DECEMBER 20, 2021 SPECIAL AND REGULAR ZBA MEETING MINUTES

THE RESIDENCES AT ENDICOTT

SUBJECT: 40-42 Endicott Street

DATE: November 4, 2021

SIGHT DISTANCE

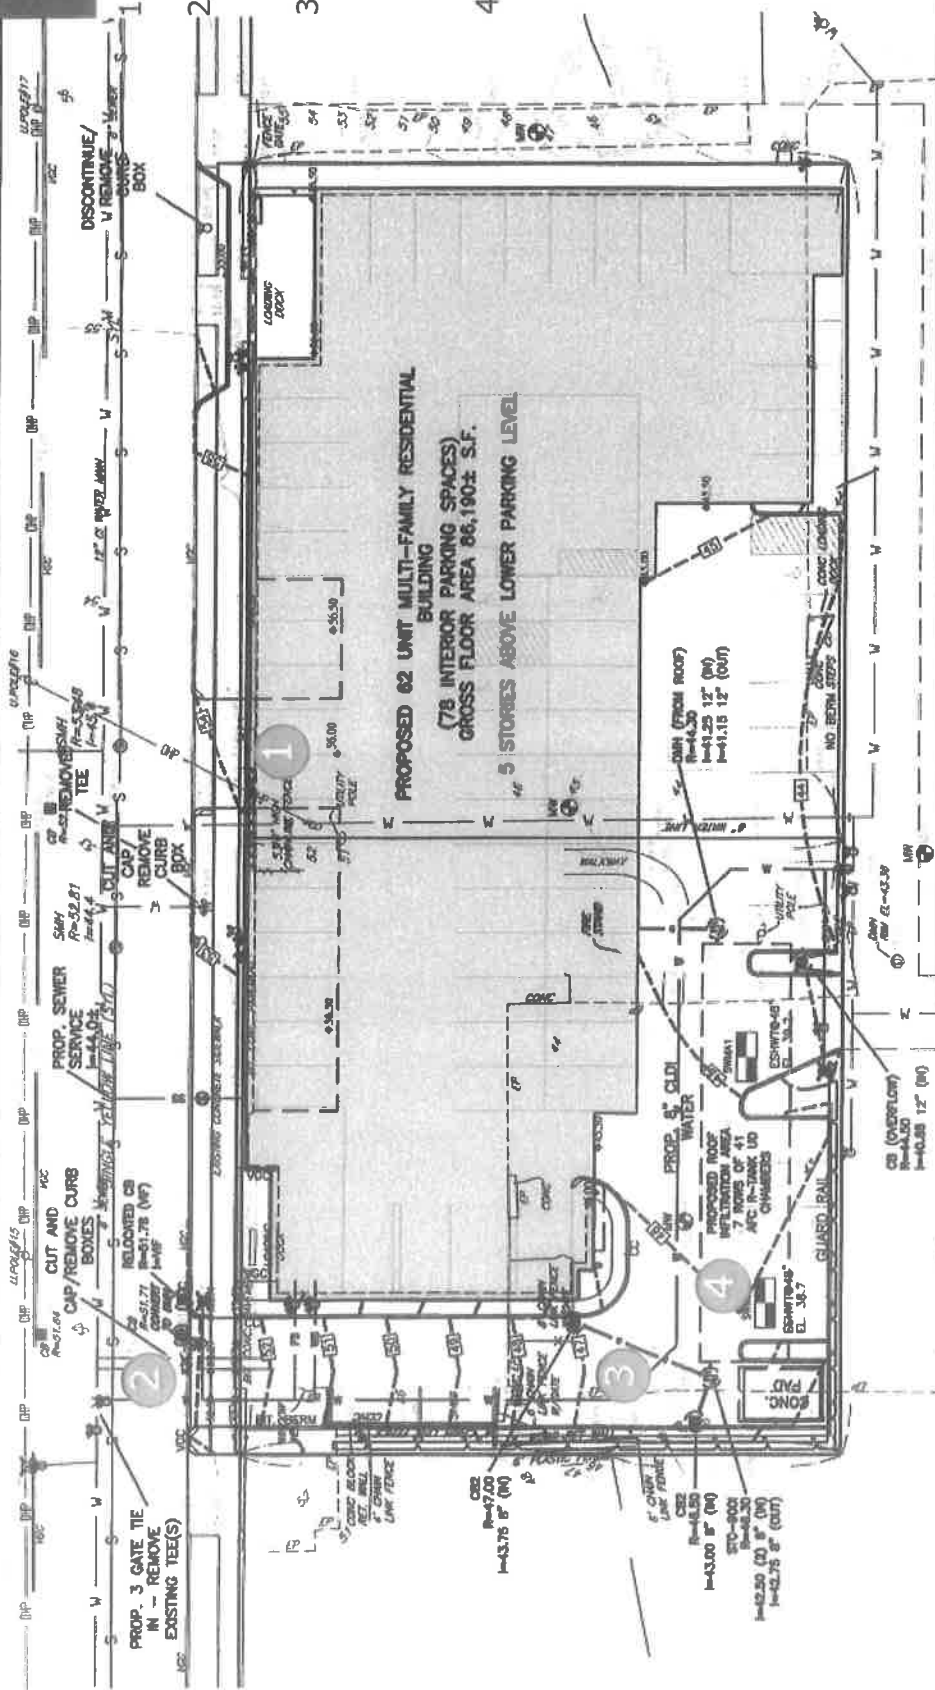
**Table 5
SIGHT DISTANCE MEASUREMENTS^a**

^dCars parked on Endicott Street impeded sight distance. Value in (f) indicated the sight distance available if no cars were parked on Endicott Street.

SITE PLAN CHANGES

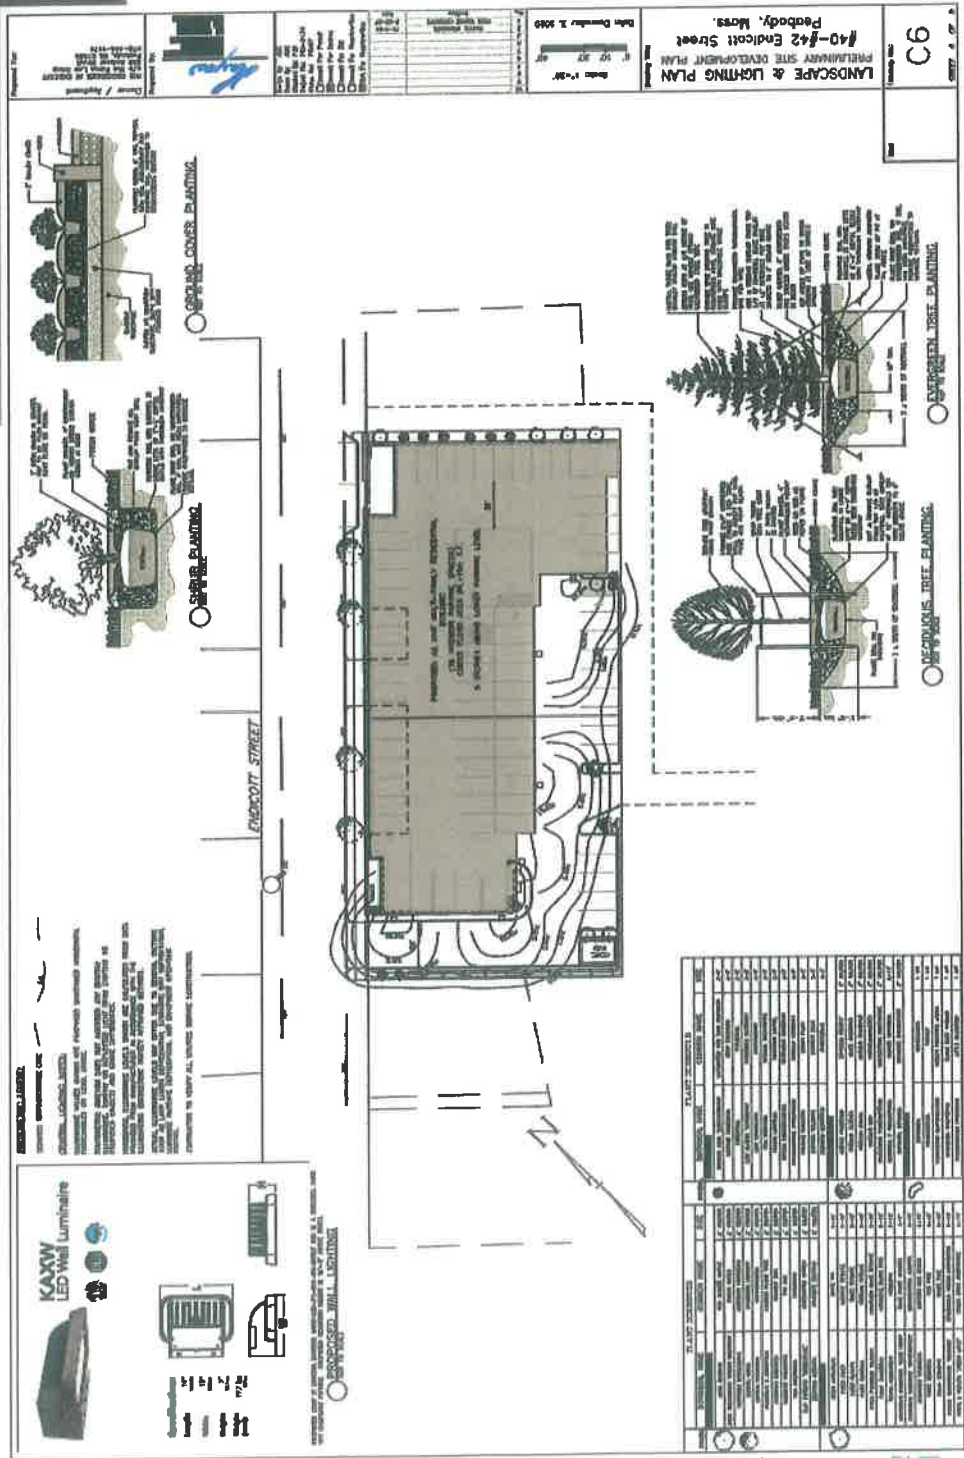
1. Relocated upper driveway entrance
2. Relocated catch basin out of driveway
3. Added on-site catch basins and a Storm -ceptor to increase TSS removal
4. Expanded infiltration system to maximum extent practicable
